Garman Homes
 Lot 0045 Serenity
 Fuquay Varina, North Carolina

HONEYSUCKLE
 SER ELEVATION B
 LOT 0045 SERENITY

10/24/22:
PROTOTYPE
REVISIONS
NOTED IN RED

REAR ELEVATION

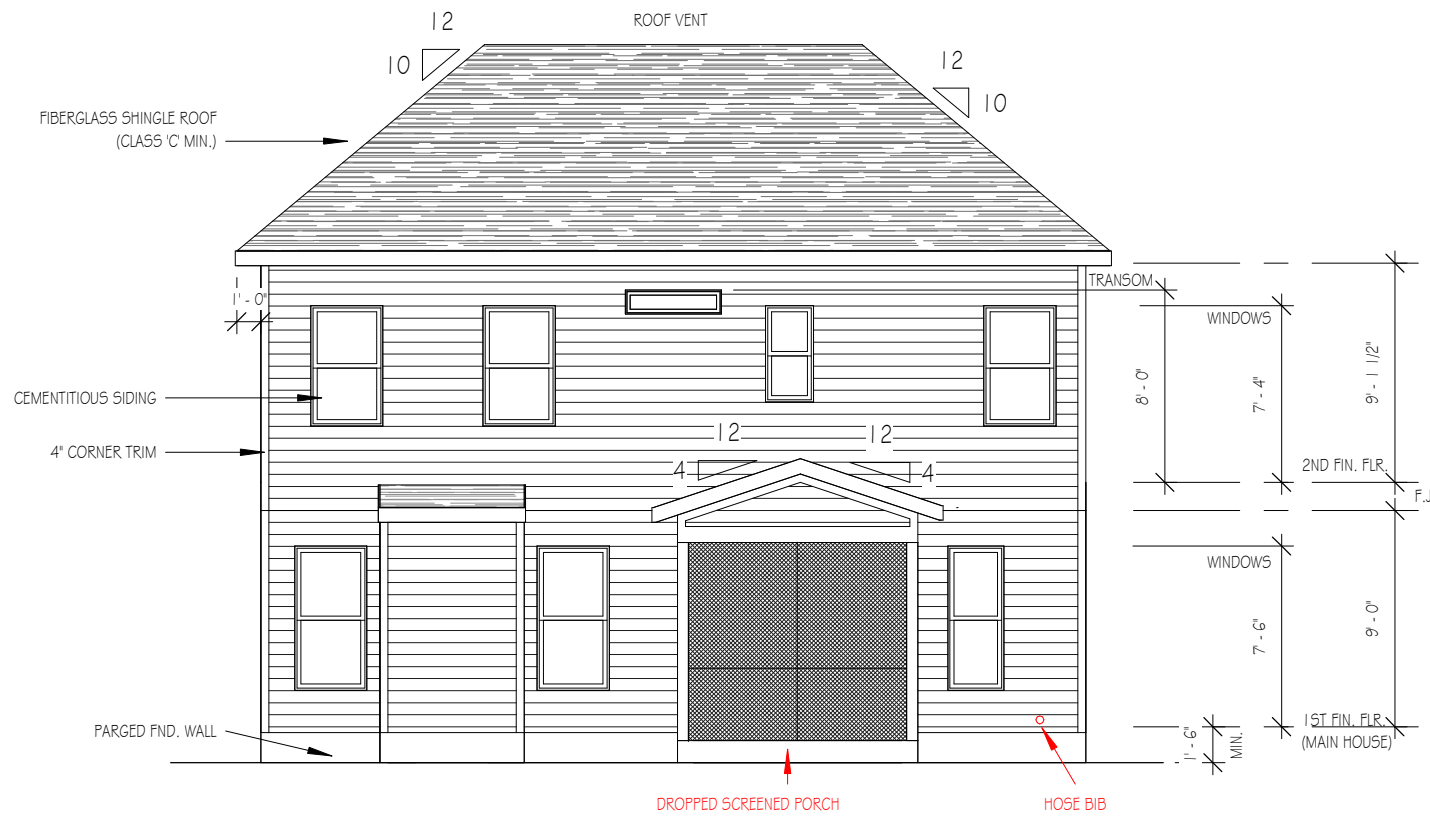
DROPPED SCREENED PORCH FOUNDATION DOWN 4" TO MATCH SITE

RIGHT SIDE ELEVATION

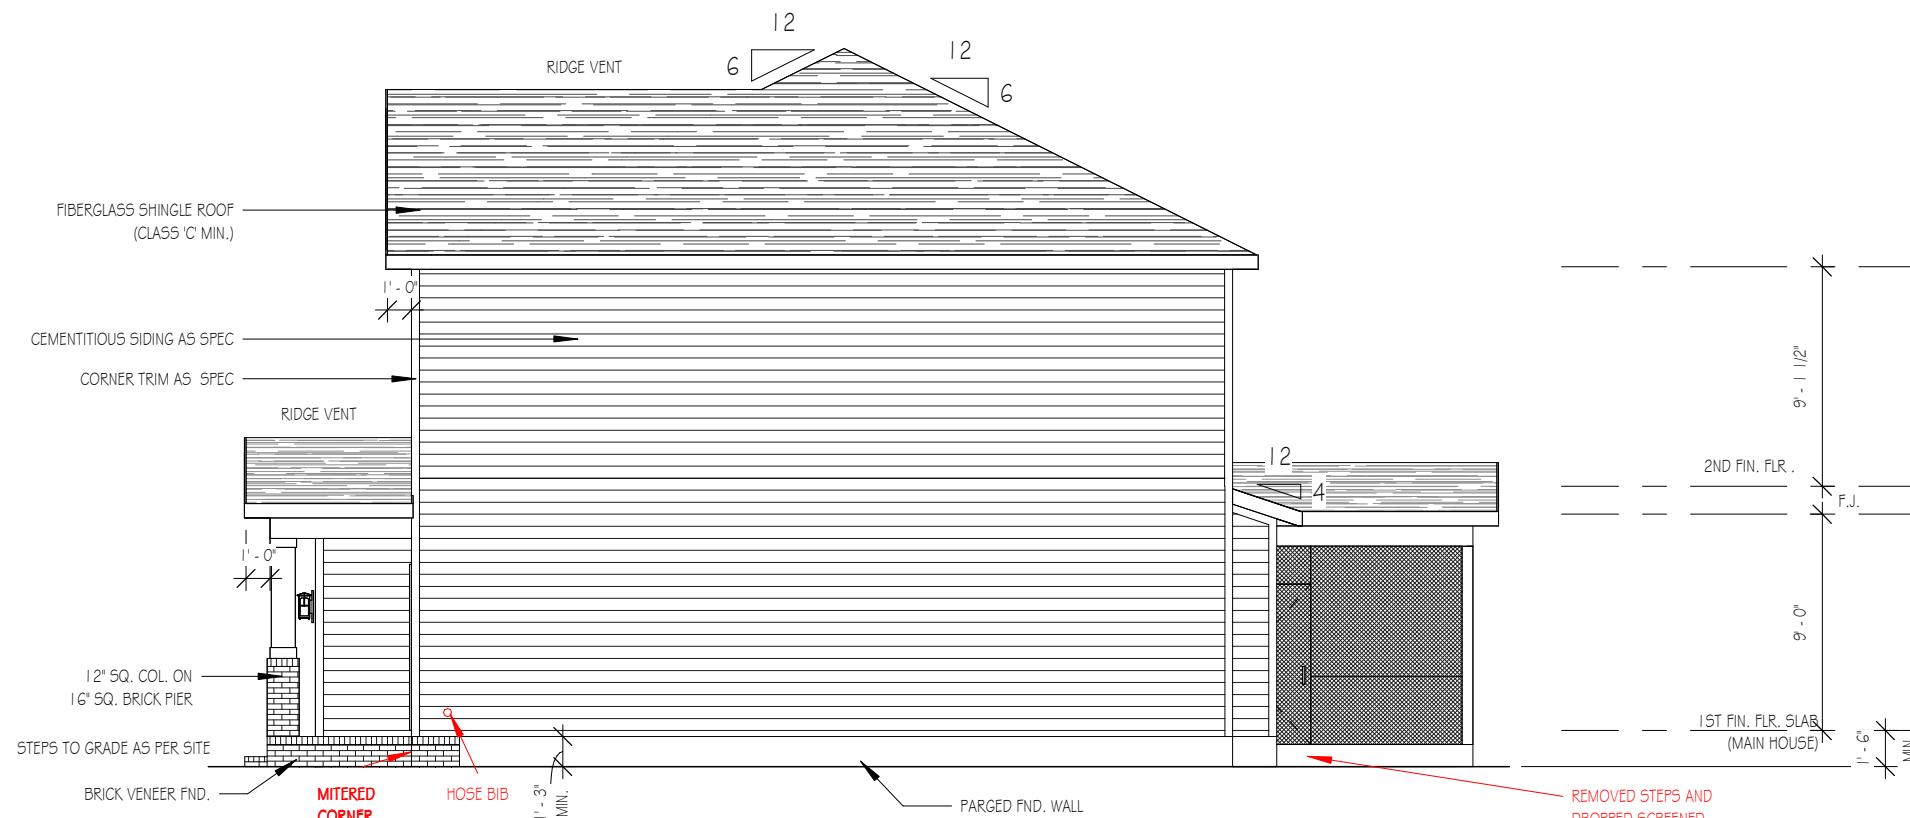
REMOVED STEPS AND DROPPED SCREENED PORCH FOUNDATION DOWN 4" TO MATCH SITE
